CALIFORNIA COASTAL COMMISSION

**STAFF REPORT: REGULAR CALENDAR**

APPLICATION NO.: 4-05-158

PROJECT DESCRIPTION: Repair/maintenance and replacement of existing equipment, pave existing work yard, 312 cu. yds. of grading (142 cu. yds. cut and 170 cu. yds. fill), and implement a Storm Water Pollution Prevention Plan (SWPPP) at an existing concrete manufacturing facility. In addition, the project includes the installation of new stormwater runoff containment, treatment, and recycling improvements consisting of a 2,213 cu. ft. (approximately 16,554 gallons) water retention basin, a 180 cu. ft. (approximately 1,346 gallons) sediment trap, a pump system, a 5,000 gallon water storage tank, and a separate stormwater catch basin for street runoff with a fossil filtration device.

EXHIBIT 4
CDP 4-05-158 (Mission Ready Mix)
Grading/Drainage Plan

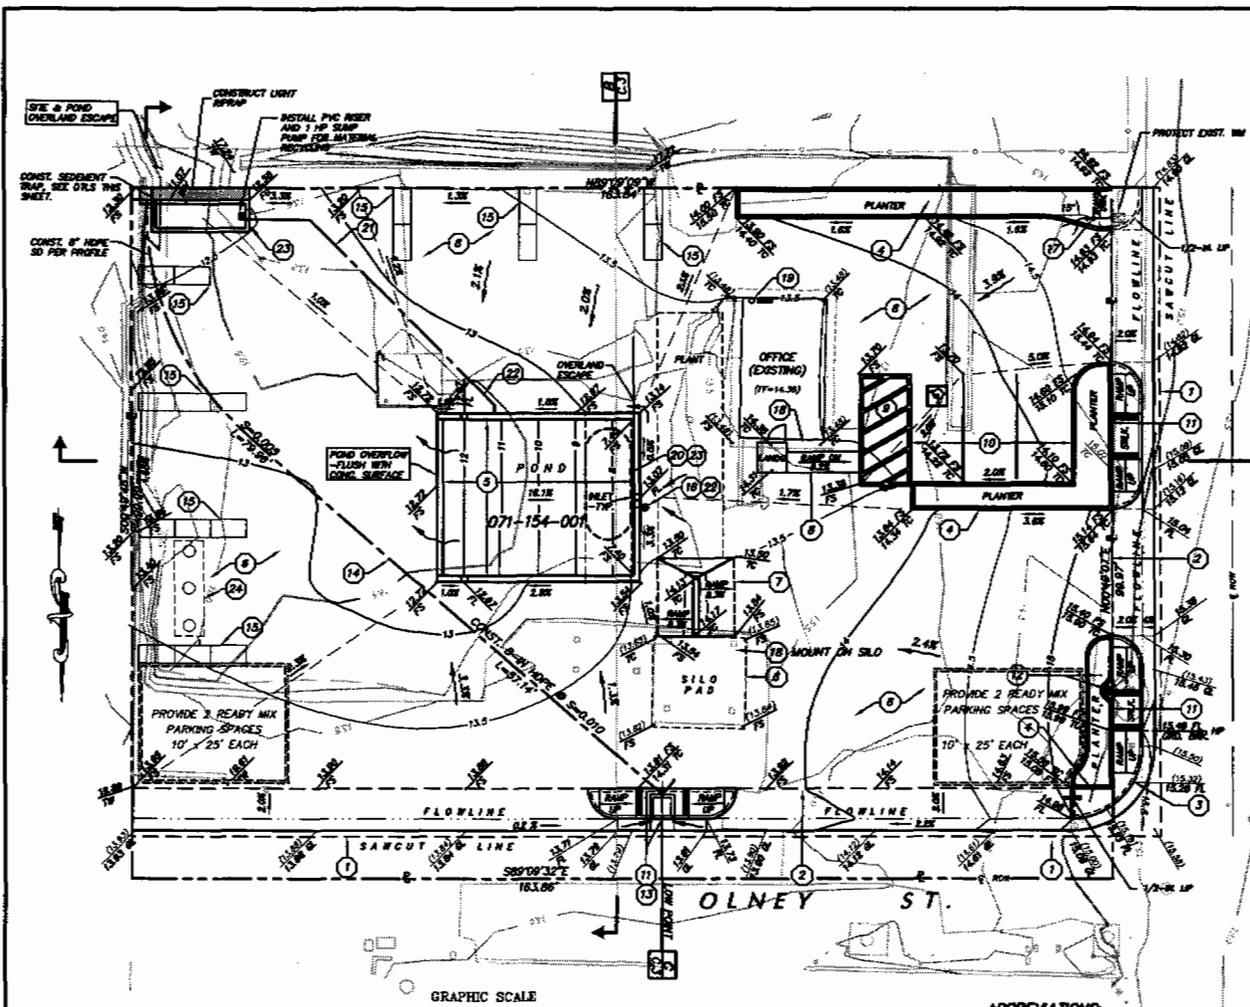
Central Coast Regional Water Quality Board (Regional Board) staff, David Innis, has conducted a review of the site plans for the Mission Ready-Mix facility proposed for development in Goleta, at the corner of Olney Street and Fairview Avenue. Mr. Innis consulted with Vyto Adomaitis of the City of Goleta, Tracy Duffey of the California Coastal Commission, and other Regional Board staff.

Based on Coastal Commission request, all storm water originating on Olney Street is to be diverted away from the Ready-Mix facility. As such, you have responded with a design that carries Olney Street storm water under the site's concrete pad, through an eight-inch High Density Polyethylene (HDPE) pipe, that discharges at the site's southwest corner. Prior to collection in the underground pipe, storm water from Olney Street will pass through a "fossil filter" to capture hydrocarbon contaminants that may be flushed off the road and carried in the storm water.

You have communicated with Mr. Innis that the 100 foot by 160 foot plant site is to be covered with reinforced concrete. Our staff has concerns that Ready-Mix operations will disperse concrete dust over the site and storm water runoff from the site could result in the discharge exceeding the 8.5 pH limit set forth in the Central Coast Water Quality Control Plan (Basin Plan). This has been problematic at other concrete batch plants within our region and can be difficult to control.

We have an opportunity, in this case, to require discharge control measures as the facility is designed to limit the concentration of pollutants in the runoff discharge. Implementing a best management practice of daily sweeping and vacuuming would be the best measures to control the source of pollutants at this site. In addition, water flowing across the site will flow along the sloping topography, which will direct water to the southwest corner. This can be a control and compliance point to assure pollutants are not carried offsite. Control measures can be placed at this point to collect the first flush of most polluted runoff. In our opinion, a containment system can be designed and constructed to collect and store one-half (0.5) inch of rainfall. This will allow the runoff to wash any concrete contaminants off the concrete pad into a storage area. A dual electronically-activated valve or gate system, controlled by rain gauge feed-back could then operate after the initial 0.5-inch of rain and allow any subsequent rainfall to discharge offsite. We envision a dual gate valve system that is normally open to the storage area. This valve would then close when rainfall exceeds 0.5 inch. Subsequently, after the first valve closes, the system opens a second gate valve to allow the discharge of relatively clean runoff. To assure compliance, we will require wet season maintenance and testing of the system and analysis of storm water samples that leave the site, for

- (2) The permittee shall submit two sets of revised final project plans clearly showing all proposed development and the location where water quality samples will be collected. Samples shall be collected in a manner and location that ensures that only discharge from the subject site (including the work yard area, sediment trap, and retention basin) is collected and that stormwater discharged from the outlet for the Olney Street catch basin and/or runoff from other offsite areas is not included in this sample.
